Amendments to the Drawings:

REMARKS

Fig. 4

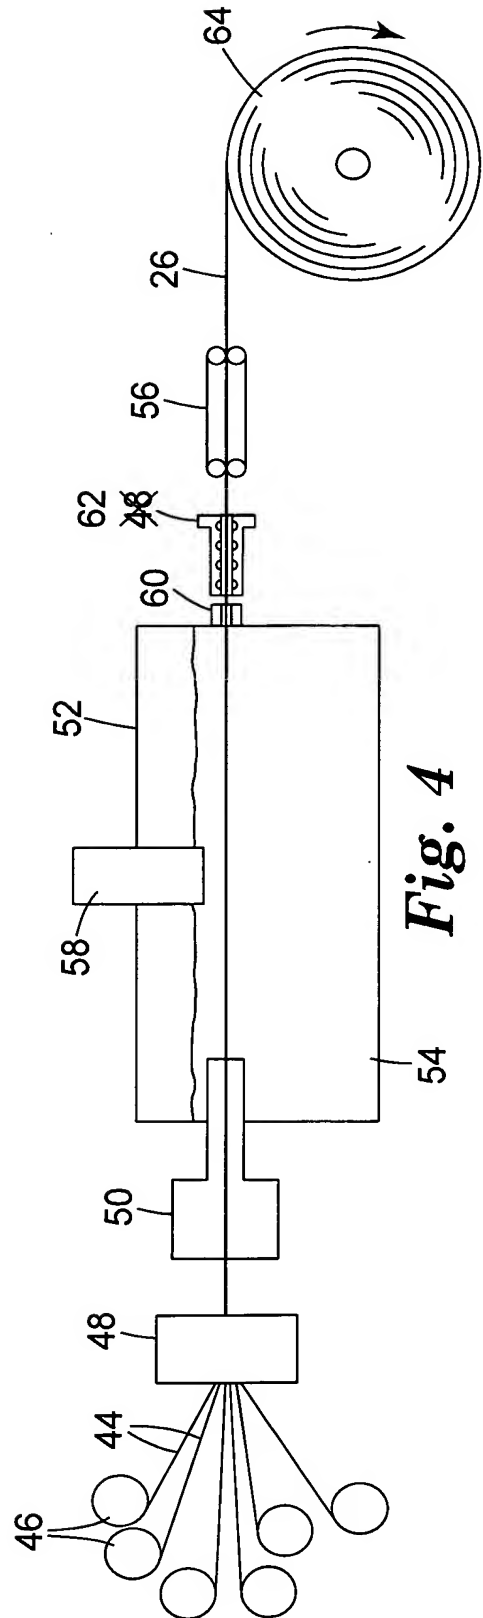
The drawings are objected to as failing to comply with 37 CFR 1.84(p)(4) because it is said reference character “48” in Figure 4 has been used to designate both the tube furnace and what appears to be the stream of gas or liquid described on page 15, line 21 of the specification and designated as reference number 62. Corrected drawing sheets in compliance with 37 CFR 1.121(d) are said to be required in reply to the Office action to avoid abandonment of the application. Further, it is said any amended replacement drawing sheet should include all of the figures appearing on the immediate prior version of the sheet, even if only one figure is being amended. Each drawing sheet submitted after the filing date of an application must be labeled in the top margin as either “Replacement Sheet” or “New Sheet” pursuant to 37 CFR 1.121(d). If the changes are not accepted by the examiner, the applicant will be notified and informed of any required corrective action in the next Office action. The objection to the drawings will not be held in abeyance.

FIG. 4 has been corrected to replace one of the reference numbers "48" with 62. Support for this amendment can be found in the specification, for example, on page 13, lines 13-24 and page 15, lines 20-24.

FIG. 4 has been amended to correct the dual use of reference number 48. Further, page 15 (and page 13) has been amended to more clearly discuss reference number 62.
